Subject: RIN 1219-AB58

**Oral Comments on 30 CFR Parts 7 and 75
Refuge Alternatives for Underground Coal Mines; Proposed Rule as published in the
Federal Register / Vol. 73, No. 116 / Monday, June 16, 2008 / Proposed Rules**

July 31, 2008

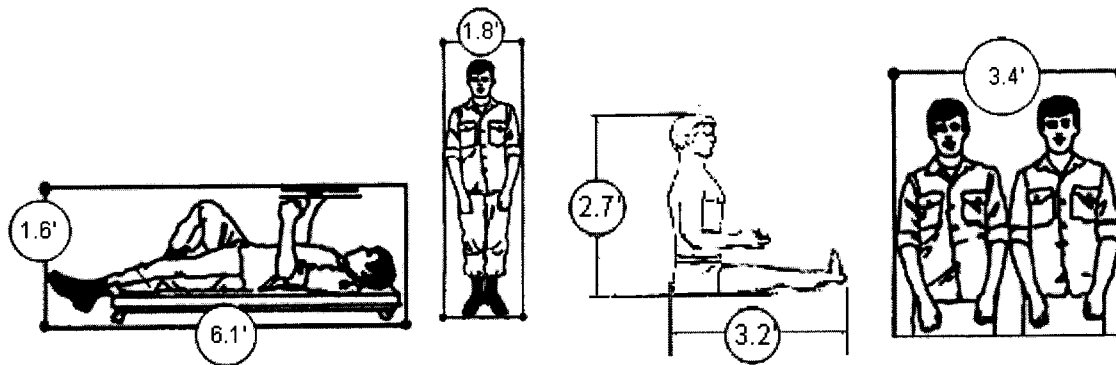
Section 7.505 Paragraph (a)(1) would require that refuge alternatives provide a minimum of 15 square feet of usable floor space and a minimum of 60 cubic feet of usable volume per person. MSHA believes that these proposed minimums are necessary to provide adequate room for miners using the refuge alternative. Usable space or volume means space or volume without stored items. The space and volume requirements are exclusive of the airlock space and volume. NIOSH design parameters requested 15 square feet and 85 cubic feet per miner. NIOSH stated that these recommendations were not to be considered absolute. Under this proposed provision, a space of 6 feet of length and 2.5 feet of width would amount to 15 square feet. If the same area has a height of 4 feet, the miner would be provided with 60 cubic feet of space. For mines with lower heights, the 60 cubic feet of space may need to be attained by increasing the length or floor area. MSHA solicits comments on these minimum space and volume requirements. Comments should be specific, including alternatives, rationale, safety benefits to miners, technological and economic feasibility, and supporting data. The area cannot be determined solely by the number of miners that would be using the refuge alternative. Miners would need some free space to operate components, drink, eat, and use the sanitation facilities—and tend to injuries. Additional space may be needed for suspended curtains, as part of a passive system CO₂ removal system. Also larger volumes seem to be more effective at dissipating heat.

This requirement is based upon a statement in the NIOSH report that was taken from a footnote in a 1986 report that referenced a 1958 Civil Defense publication (TB-5-3, May 1958). That document was researched by the NIOSH contract authors. If they had would have found it providing guidance for family fall out shelters that requested 80 cubic feet per person. It has no relevance to this application, a fact that has been confirmed to me by the NIOSH staff. If the MSHA staff would have called them they would have been told the same.

Fallout shelters were designed for occupancy by untrained civilians for periods of at least two weeks. Underground emergency shelters are designed for the survival of trained miners for a period of not more than 96 hours but most likely less than 48 hours.

Images taken from the US Department of Defense Human Engineering Manual (MIL-HDBK-759C) and modified to indicate English units verse Metric units.

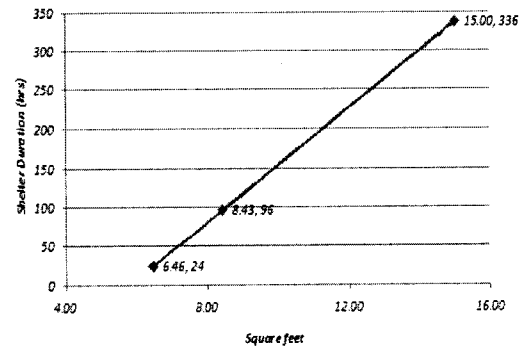
The US Department of Defense Human Engineering Manual (MIL-HDBK-759C) indicates that a supine man should have a space of 1.6 feet high by 6.1 feet long. It defines the space required for a man sitting to be 2.7 feet high by 3.2 feet long. (If we assume that these are the two extreme positions in a shelter, we get a maximum volume of 29.6 cubic feet and a floor space of 10.9 square feet. (This value is arrived at by using the height of the sitting man, the length of the supine man and the design shoulder width.) As a point of reference, the South African regulation is 6.4 square feet of floor space with no volume value (Chief Inspector of Mines Directive B5, 14 Feb. 1994).

Since low-coal mines can result in interior shelter heights of 2 feet, the sitting position would not be applicable. In those situations, the volume would be limited to that of the supine position with a volume requirement of 17.6 cubic feet.

Additionally, the Department of Defense document identifies as 3.4 feet the space required for two men, which provides some guidance for the number of miners in given shelter length.

I: Pressure history of high explosive (HE) and thermobaric explosive (TBE) detonations

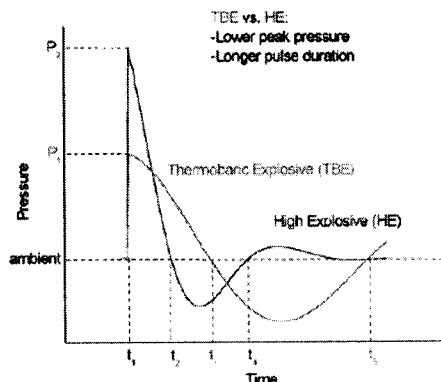
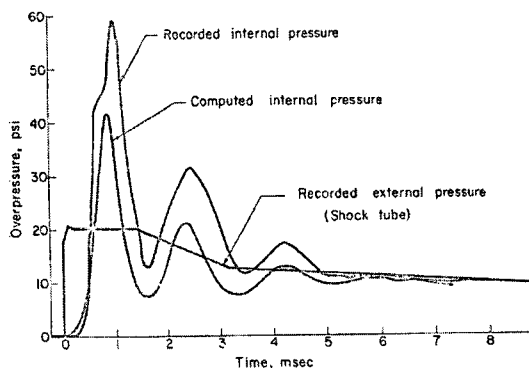
Agree. As discussed in the Comment 11 the period listed in the text is 0.2 seconds. This is effectively a static load and provides multiple means of testing. While there has been discussion of using a period in the few millisecond range, the seminal study on the subject of human effects of blast waves, "The Biodynamics of Airblast" by Clayton S. White, et al sponsored by the Defense Nuclear Agency in 1971, indicates that in closed environment such as building or mines that wave reflection and wave stacking result in not only higher effective overpressures but prolonged durations. An overpressure event of 15 psi in mine entry could easily produce an effective duration exceeding 0.5 seconds that would not affect the design criteria for a shelter but would increase the trauma of anyone in the blast zone.

Additionally the internal amplification of the overpressure due to wave stacking within the body found was found in these studies. An external pressure of 20 psi resulted in an in-lung pressure of 60 psi (see page 77 of the above report). The cause of fatality in animal studies has shown to be damage to the lungs.

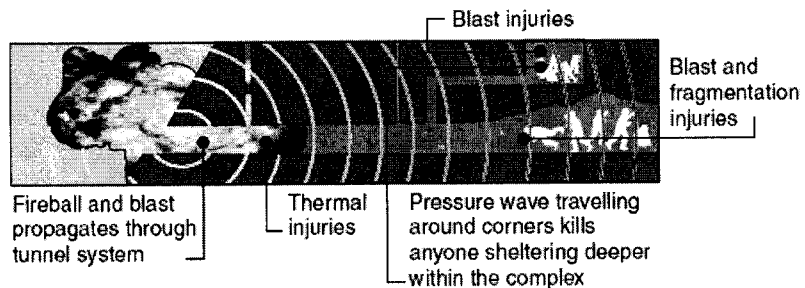
The US and UK military have deployed thermobaric weapons in the cave complexes in Afghanistan. They have reported from a military standpoint that they are effective.

A recent article on their application included the image here. Similar articles on these weapons places severity of the trauma inflicted in a closed space such as mine tunnel at three times those experienced in open air. Current design criteria call for a design overpressure of at least 13 psi for these devices. Based upon these and the above values the 15 psi value for survivability of the shelter is sufficient as levels higher than that would not likely result in survivors.

All of this is relevant to an explosion in a mine in that it decreases the likelihood of survivors of an over pressure greater than the threshold values discussed above.

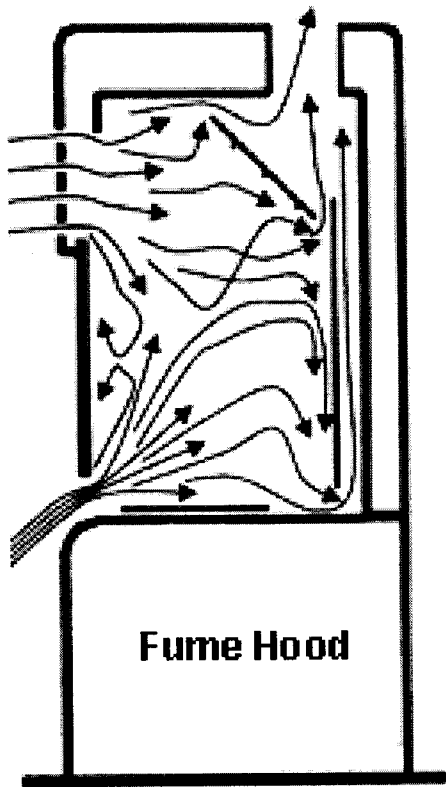
Section 7.506 Paragraph (c) would require that breathable air supplied by compressed air from cylinders, fans, or compressors provide a minimum flow rate of 12.5 cubic feet per minute of breathable air for each miner. MSHA proposes to use 12.5 cubic feet per minute of breathable air as a required volume for each miner based on the amount of air needed for respiration and dilution of CO₂ and other harmful gases. In addition, the 12.5 cubic feet per minute flow rate would assure positive pressure to prevent contamination from the mine atmosphere. A maximum positive relief valve would need to be located in the refuge alternative. MSHA requests comments regarding the flow rate. Comments should be specific including alternatives, rationale, safety benefits to miners, technological and economic feasibility, and supporting data.

MSHA considered the enclosed space as similar to a loose-hood respirator using supplied air. Flair Corporation Bulletin 270 revision H (4-01) indicates that OSHA requires a supply air of 6 to 15 cfm (360 to 900 cfm) for supplied air hoods (continuous flow supplied air respirators) to purge accumulated carbon dioxide. The 12.5 cfm per person fell within this range. Engineering handbooks recommend ventilation rates in the range 10-15 cfm of fresh air per person for offices with 12.5 cfm per person being the midpoint of this range. MSHA believes that these quantities are conservative. However, they are design parameters for a life support system, which demands a more cautious approach. In addition, compressor wear reduces performance and the system will become less efficient with age. The Agency considers that the use of compressed air cylinders as the sole means of providing breathable air may be impractical and encourages mine operators to consider other options. As MSHA pointed out in PIB P07-03, a fan or equivalent method should be used to force fresh air into the hole with enough positive pressure to overcome total mine pressure to deliver sufficient quantities of breathable air. Compressor air intakes should be installed and maintained to assure that only clean, uncontaminated air enters the compressors. Mines should assure compressors have the capacity to deliver the required volume of air at the point of expected usage.

Open circuit respirators such as the one used in this analogy are designed with great care to ensure that the flow of air routes any contaminants in such a manner that they do not become trapped with the space. The document referenced could not be found however, the laboratory fume hood a more appropriate analogy. It is designed to ensure sufficient ventilation of large space such that hazardous gases are continuously removed from all corners of the space. The airflow and surfaces are designed to ensure sufficient turbulence of the high airflow (125 cfm) within the hood to ensure sufficient movement to carry any hazardous compounds from the space. This is a good analogy for what is needed to happen if an inflatable stopping were erected in a hazardous environment and the space needed to be purged.

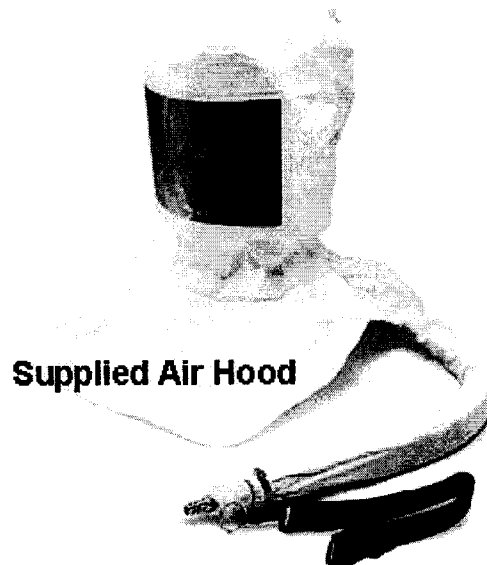
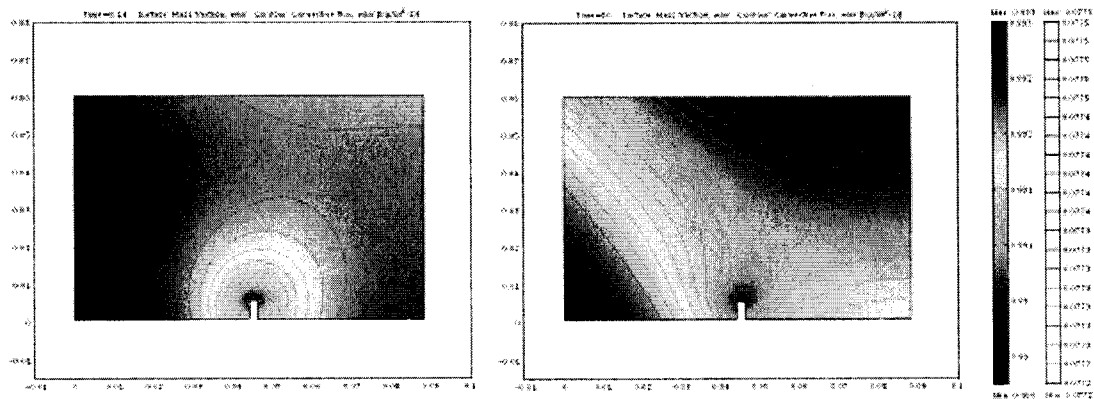
Evaluations done by various manufactures and internally at MSHA have indicated the difficulty and complexity of purging a space once it is contaminated with carbon monoxide. These consideration have been taken into account by the manufacturers that have been through the West Virginia approval process. And those units can be successfully purged although the airlock should eliminate that need.

West Virginia University was asked to conduct a computational fluid dynamics model of PIB 07-03 with the assumption that the space is initially contaminated with toxic levels of carbon monoxide. The results could not demonstrate a means of purging the space using the MSHA standards.

For those looking at this in black and white, the dark red colors in the lower left of both images are above the fatal concentration of carbon monoxide and dark blue area in the upper right of the right image are carbon monoxide free.

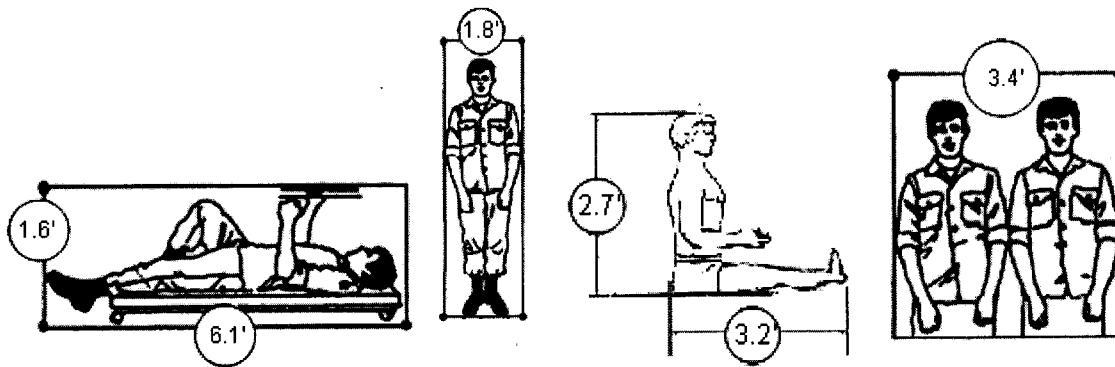
This requirement is based upon a statement in the NIOSH report that was taken from a 1958 Civil Defense publication (TB-5-3, May 1958) providing guidance for family fall out shelters that requested 80 cubic feet per person. It has no relevance to this application.

Fallout shelters were designed for occupancy by untrained civilians for periods of at least two weeks. Underground emergency shelters are designed for the survival of trained miners for a period of not more than 96 hours but most likely less than 48 hours.

The net effect of this provision would be reduce the effective occupancy of current shelters by up to 50% and more than double their number underground. This increases

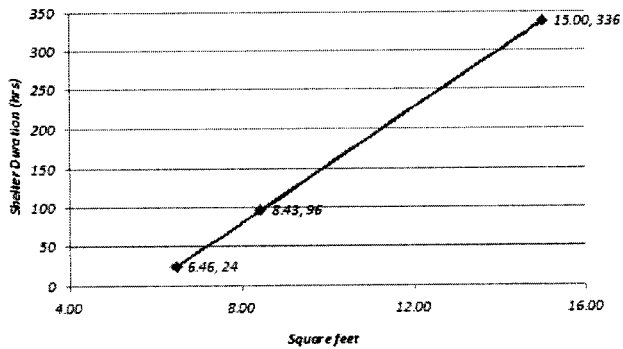
Another approach that has been requested by some could be to extrapolate between the values utilized in South Africa mine shelters since the 1990's of and those of the U.S. Navy for 100 men in fallout shelters for 14 days. Using the approach in graph on below this would result in a value of 6 square feet.

However, it is important to remember that emergency shelters are the last resort in the event of an accident to ensure survival not to ensure comfort. As one miner told me after a training session on all the things we have done to improve their chances for escape, "With all these extra escape additions if I have to, the decision to get into a shelter or not boils down to the shelter or a body bag...it's not that a hard a choice." Comfort is not the main consideration...survival is the ONLY consideration.
